- A. Incorrect Inlet Fuel Line Connection to Fuel Filter Base - MIE 260 S.N. 5940856 and Below
- B. Audio Warning System Being Activated on Engines With Closed Cooling System - MIE 230/260/340 Models
- C. Closed Cooling Thermostat Housing Assemblies and Covers - 305/350 CID V-8 and 454 CID V-8 G.M. Engines

**Figure 1. Fuel Filter Base Connections**

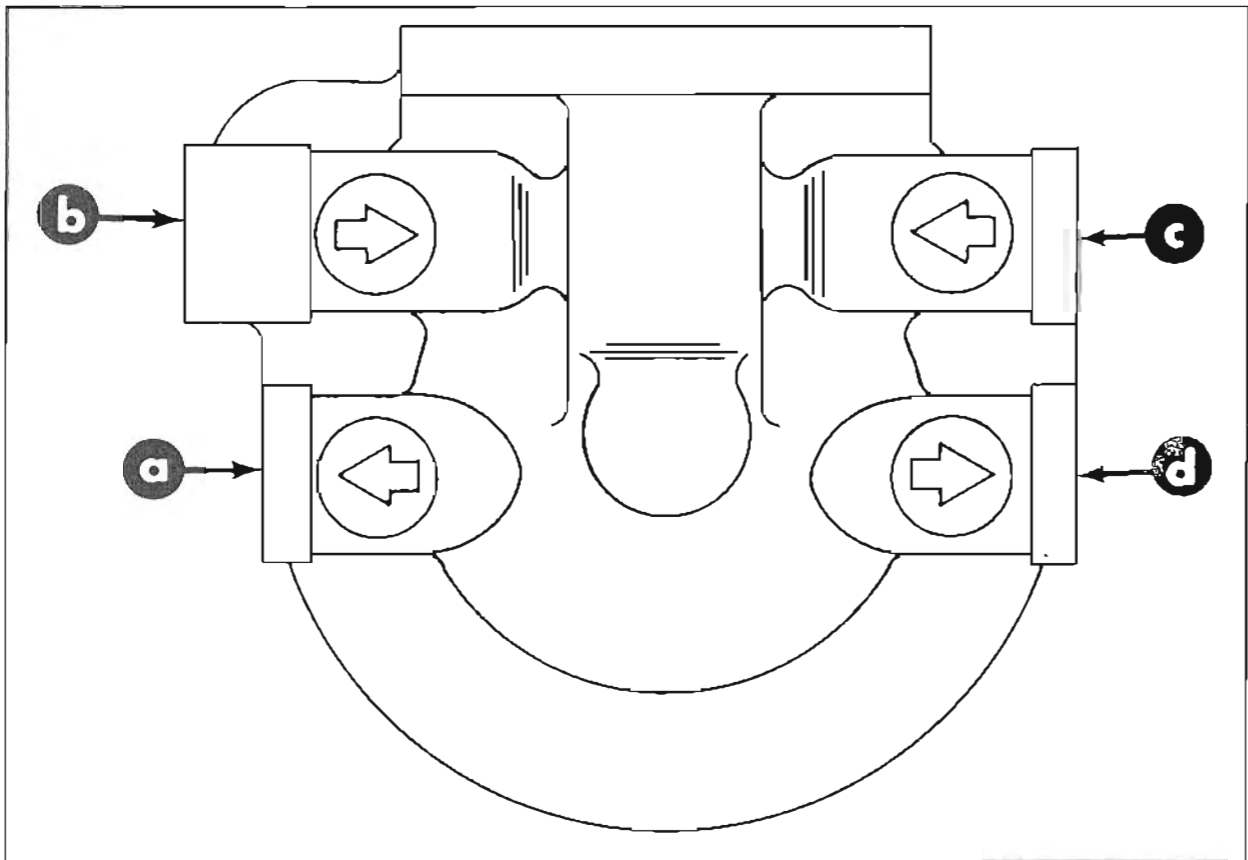
The engine models above may have the inlet fuel hose connected to the outlet of the Fuel Filter Base. The engine will operate properly, but the fuel will not be filtered as is intended. Inspect all MIE 260's that are below the Serial Number 5940856 and move fuel inlet hose to Position "b" in Figure 1. Remove pipe plug from Position "b" and reinstall in Position "a".

**Figure 2. Difference Between Senders**

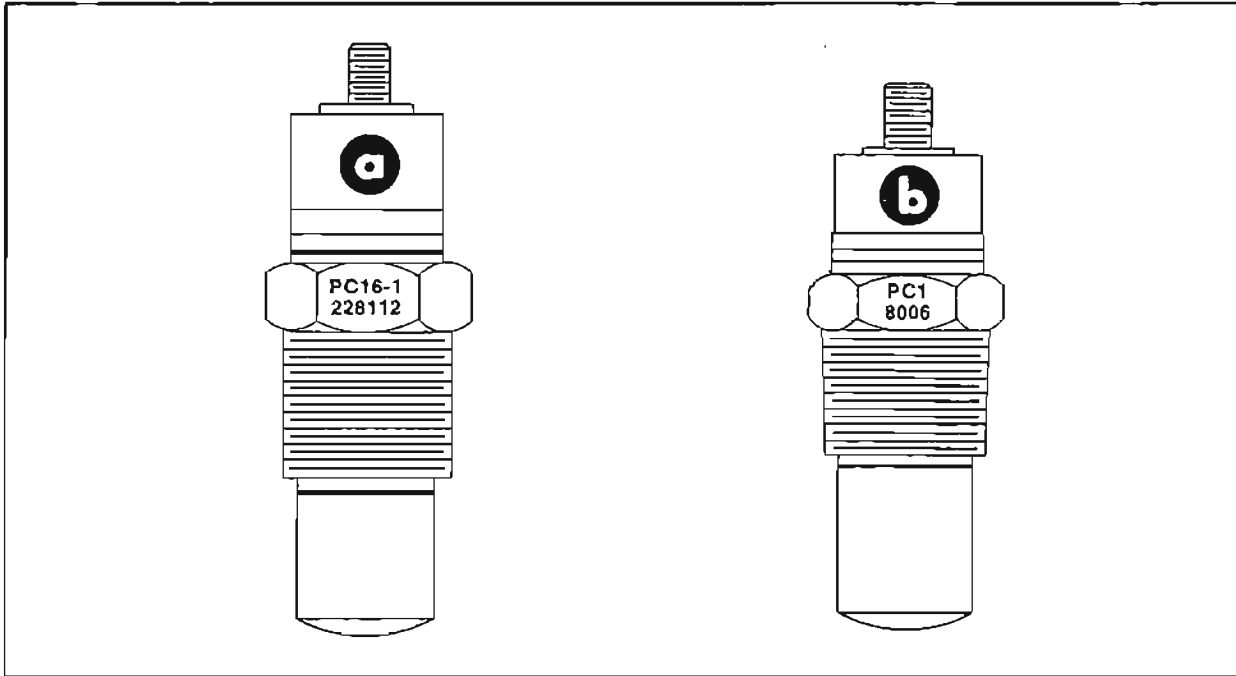
The Audio Warning System (Buzzer) may indicate a false overheating condition under certain operating conditions on the above model engines.

The Temperature Warning Sender Part No. B-48952, that is installed on all engines is activated (Sender closes) at 190°F (88°C) to 200°F (93°C). It does not open until 150°F (65°C) to 170°F

(76°C). Since it is common for a closed cooled engine to exceed 190°F (88°C) under certain conditions, the Sender is activated.

To correct the above described condition, install Temperature Warning Sender Part No. B-87-86080. This Sender will activate (Sender closes) at 215°F (101°C) to 225°F (107°C) and open again at 175°F (79°C) to 195°F (90°C). The B-87-86080 Sender **MUST BE** used on all closed cooled MIE 230/260/340 model engines. Also all closed cooling kits for the above model engines will have the B-87-86080 Sender in it.

**Figure 3. Location of Mounting Holes in Thermostat Housing and Cover Assemblies**

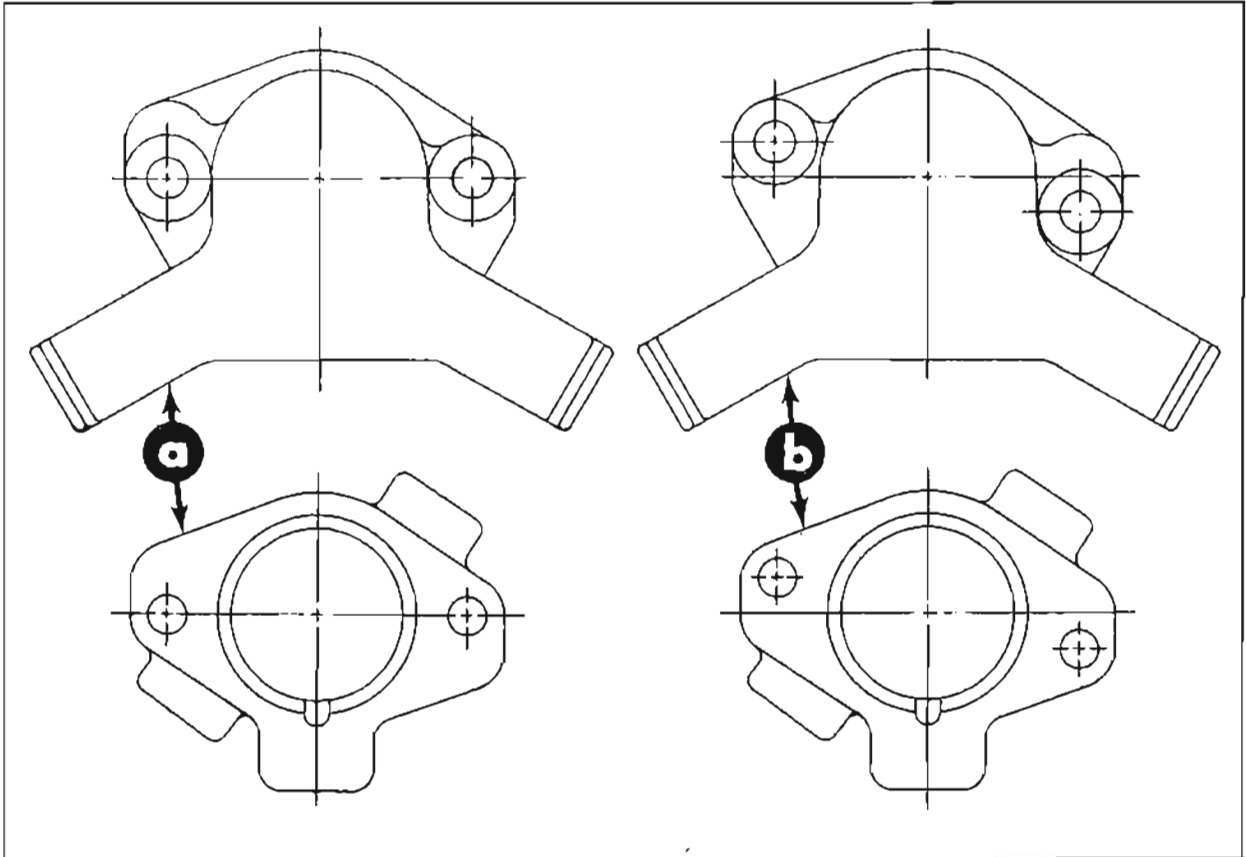
Occasionally a report is received in our Service Department about a mismatch between the Thermostat Housing and Cover Assemblies when installing a Closed Cooling kit. This mismatch will result in a coolant leak. The thermostat housings and covers are made from the same basic castings. HOWEVER, the drilled holes, for mounting the assemblies to the intake manifold, are in different locations for the small block and large block V-8 engines. Refer to Figure 3 for correct location of mounting holes in the different assemblies.
